**Addendum to  
Appendix 15  
Strategic Flood  
Risk Assessment**

## Proposed Material Alteration to Appendix 15 Strategic Flood Risk Assessment (SFRA) – Addendum to SFRA

#### Proposed Material Alteration Map Item 1 – Map 3

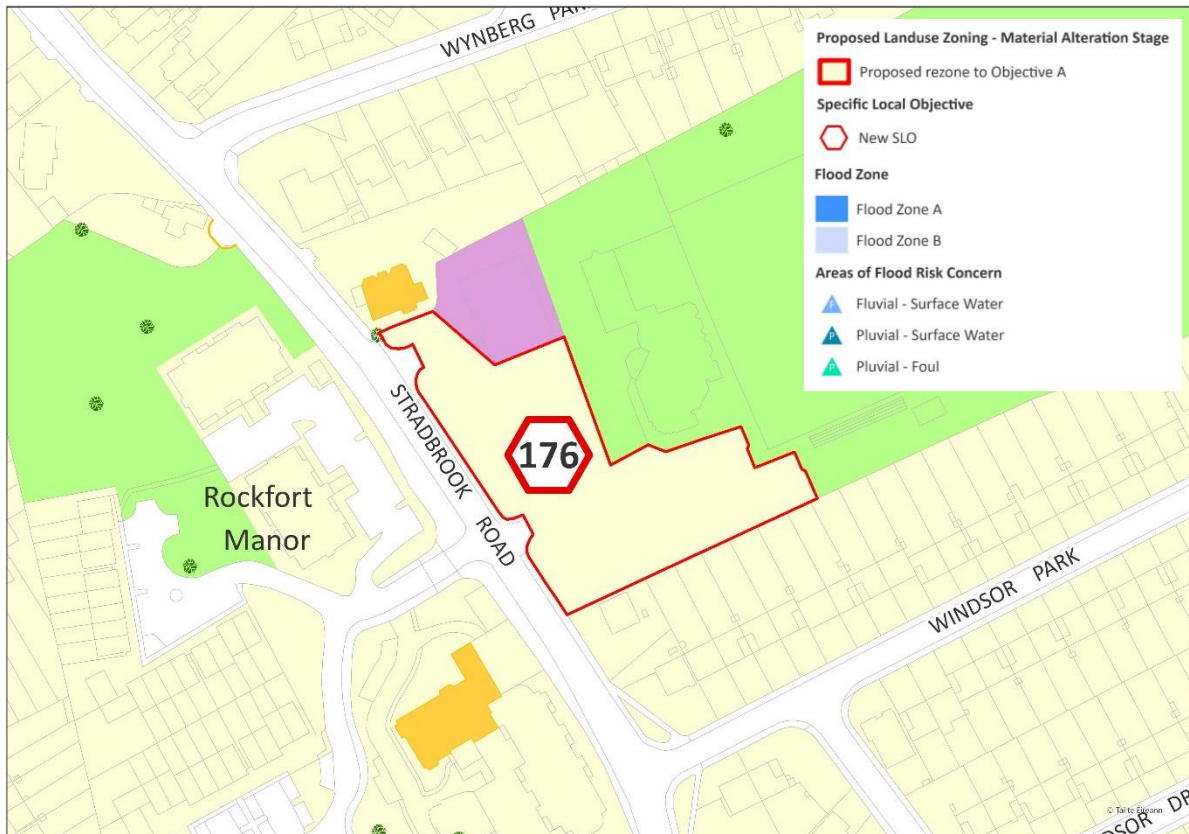
Rezone from Objective E - To provide for economic development and employment - to A - To provide residential development and improve residential amenity while protecting the existing residential amenities.

The site is wholly located in Flood Zone C (i.e. outside Flood Zone A and Flood Zone B) and therefore appropriate for highly vulnerable, less vulnerable and water compatible development in line with the OPW Guidelines and CDP SFRA. A Plan Making Justification Test is not necessary. No OPW recorded historic flooding is located within the vicinity of the site. Per the CDP SFRA, development of these lands may still require a site-specific Flood Risk Assessment (SSFRA) as there may be sources of flooding not taken into account by Flood Zoning. Any future development will be required to comply with relevant surface water management guidance and satisfy the range of other proper planning and sustainable development considerations.

### Proposed Material Alteration Map Item 1 - Map 6

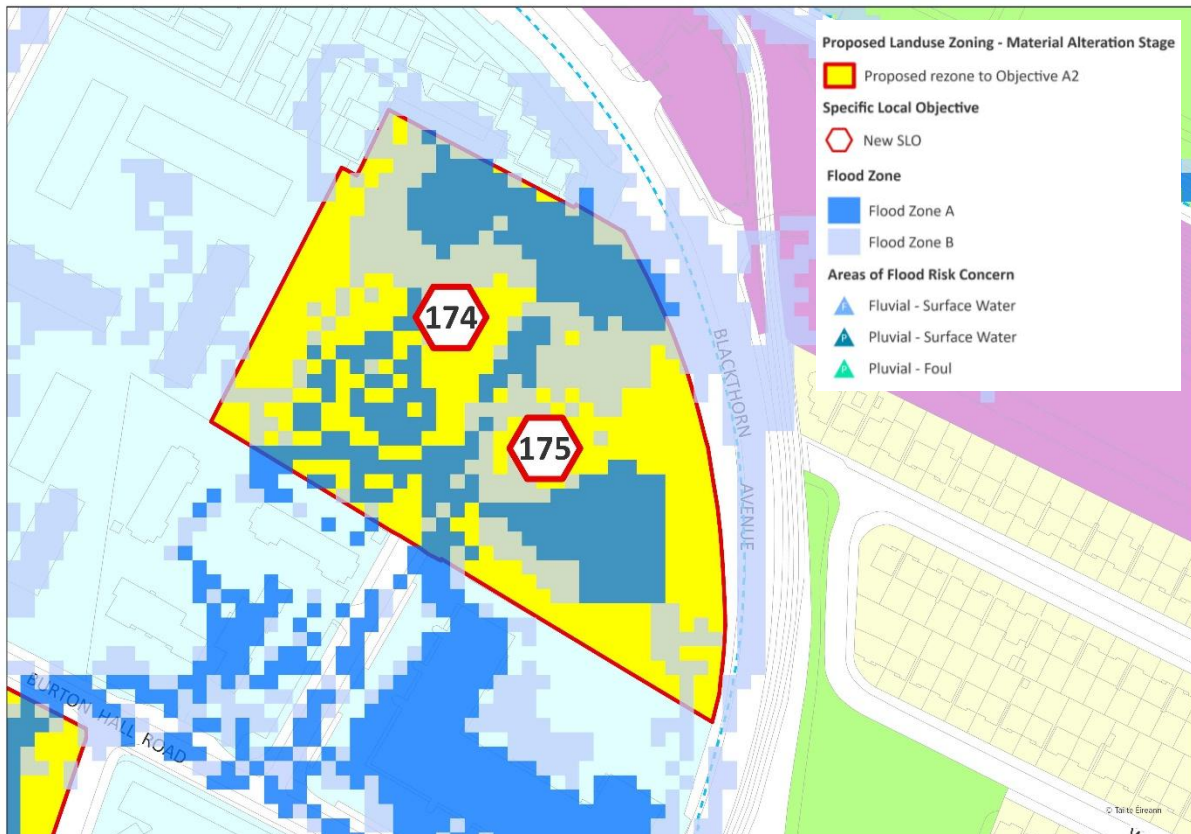
Rezone from OE -To provide for office and enterprise Employment to A2 - To provide for the creation of sustainable residential neighbourhoods and preserve and protect residential amenity  
The proposed revised zonings includes lands in flood zones A and B.

Specific Local Objectives to address flooding has been proposed as follows:

(Note: In addition to the SLO it should be noted that this area will be required to meet the requirement so section 6.2.5 of the CDP SFRA. This includes addressing the impacts of 0.1% flood event.)

SLO 174 - Any development on the site shall be accompanied by a masterplan which shall:

- Include a Site-Specific Flood Risk Assessment with details of the flood zone A and B extents and the Climate Change High-End Future Scenario (HEFS) provided with highly vulnerable uses on

first floor and above, subject to access and egress, and appropriate setting of ground floor finished floor levels.

- Address foul drainage capacity and servicing by way of an interim solution to the satisfaction of Uisce Eireann and the dlr Municipal Services Department.

**Proposed Material Alteration Map Item 5 – Map 6**

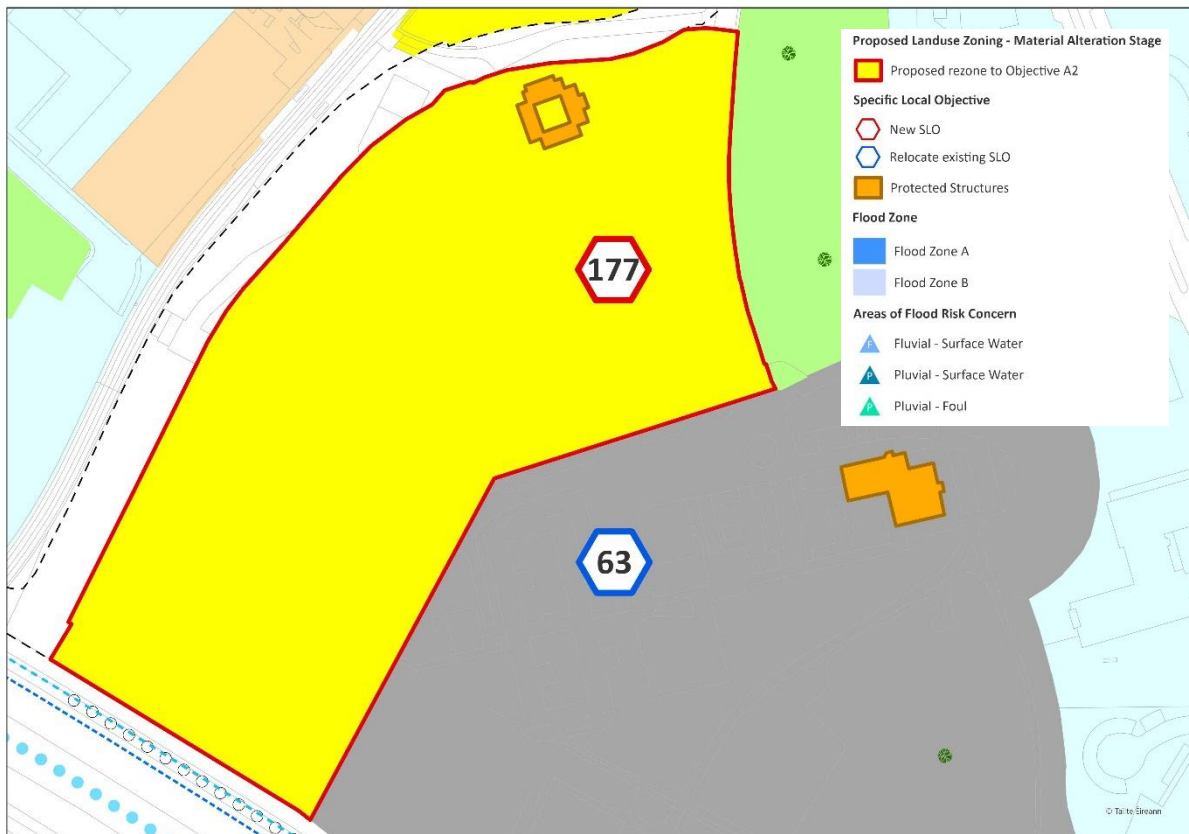
Rezone from OE -To provide for office and enterprise Employment to A2 - To provide for the creation of sustainable residential neighbourhoods and preserve and protect residential amenity  
The proposed revised zonings includes lands in flood zones A and B.

Specific Local Objectives to address flooding has been proposed as follows:

(Note: In addition to the SLO it should be noted that this area will be required to meet the requirement so section 6.2.5 of the CDP SFRA. This includes addressing the impacts of 0.1% flood event.)

SLO 178 - Any development on the site shall:

- Be accompanied by a Site – Specific Flood Risk Assessment with details of the flood zone A and B extents and the Climate Change High – End Future Scenario (HEFS) provided with highly

vulnerable uses on first floor and above, subject to access and egress, and appropriate setting of ground floor finished floor levels.

- Address foul drainage capacity and servicing by way of an interim solution to the satisfaction of Uisce Eireann and the dlr Municipal Services Department.

### Proposed Material Alteration Map Item 3 – Map 14

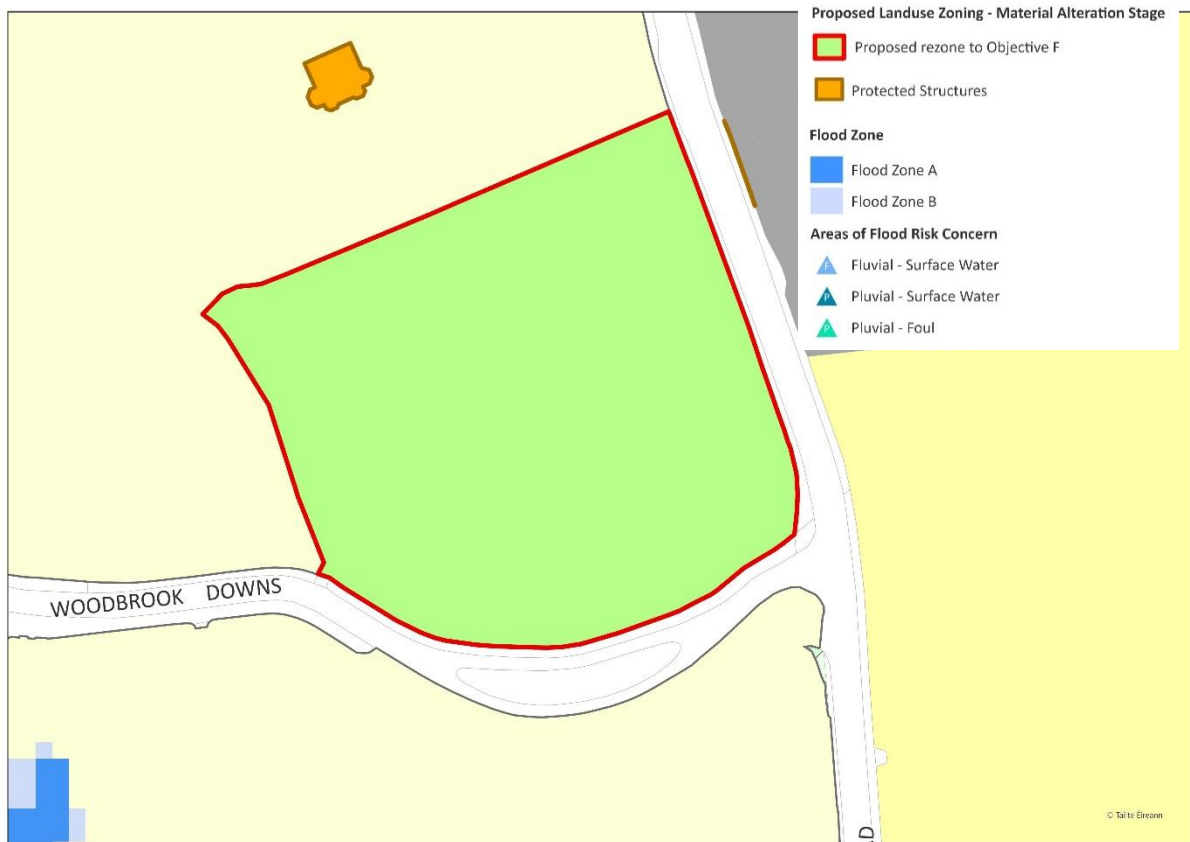
Objective F - To preserve and provide for open space with ancillary active recreational amenities to Objective A - To provide residential development and improve residential amenity while protecting the existing residential amenities.

(Note: These lands are currently zoned Gb and were proposed to be rezoned to objective F as part of the variation)

**Proposed Material Alteration Map Item 6 – Map 14**

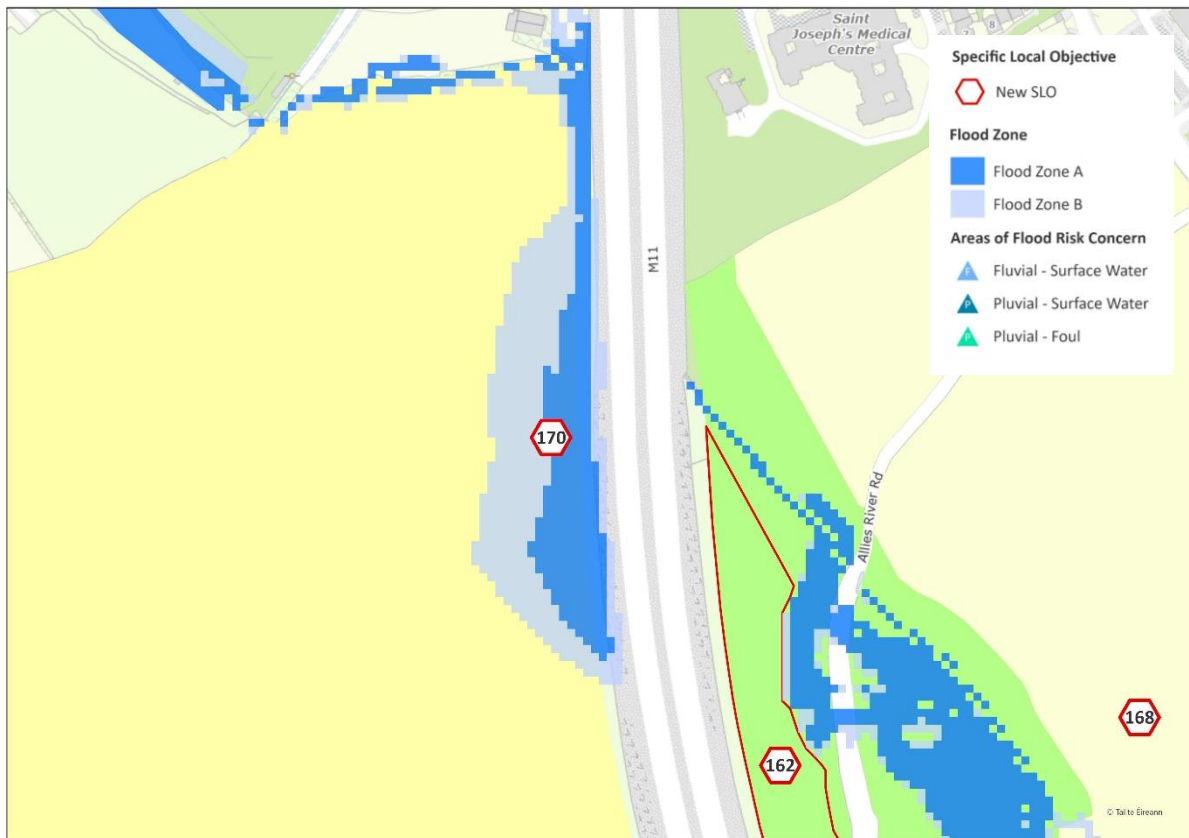
Objective A - To provide residential development and improve residential amenity while protecting the existing residential amenities to Objective F - To preserve and provide for open space with ancillary active recreational amenities.

Taking into account the OPR submissions and other submissions which raised issues it was recommended in section 3.8 of the Chief Executive report that parcel 6 be rezoned to land use objective F - open space. This would allow for water compatible uses only.

## Proposed Material Alteration Map Item 20 – Map 14

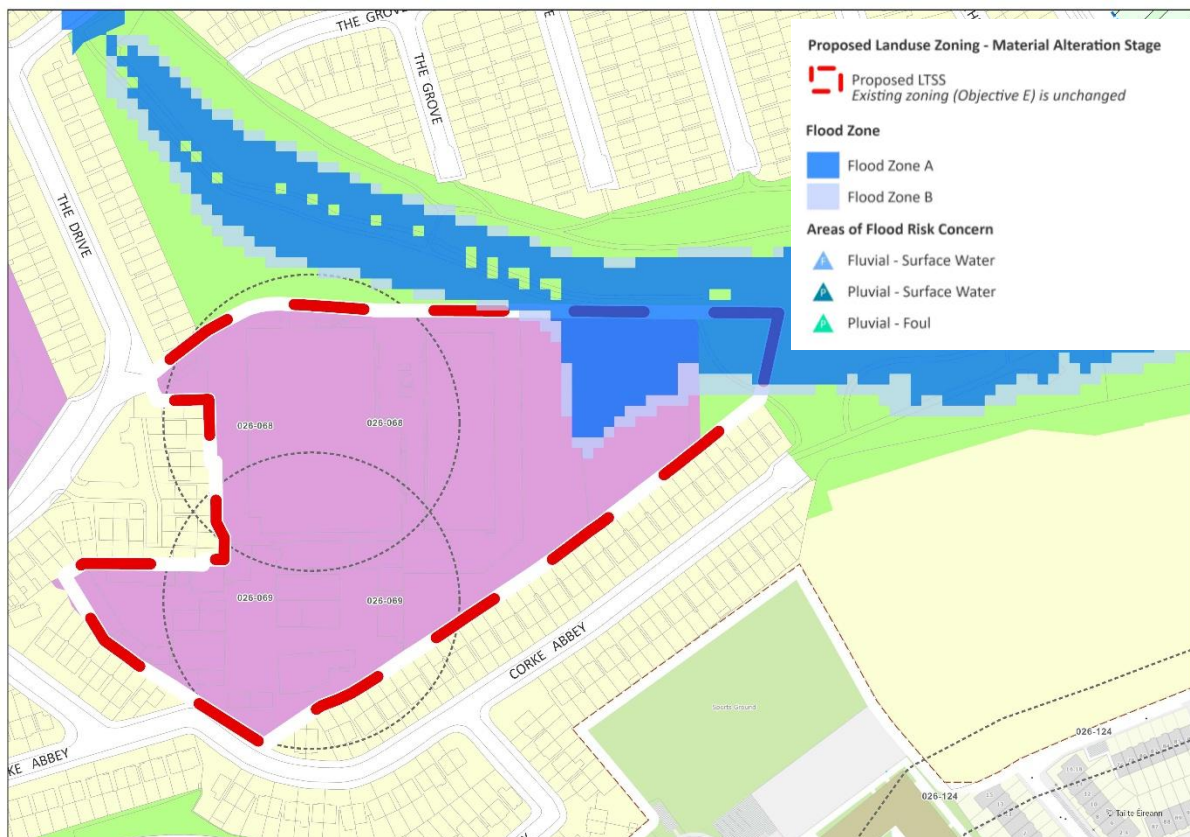
At the downstream end of the Crinken Stream there is flooding to an area zoned for Economic Development and Employment (1b) which is currently carparking. This area is part of a proposed LTSS which has been designated by way of a Proposed Material Alteration. See Proposed Material Alteration Item 20 on map 14.

As set out in the SFRA which accompanies Proposed Variation No.1, *“redevelopment of this land for less or highly vulnerable development does not pass the Plan Making Justification Test and only water compatible uses will be permitted with Flood Zone A and B.”* As the LTSS is not a rezoning it is considered that no additional change is required. Any future rezoning would need to address flood risk.
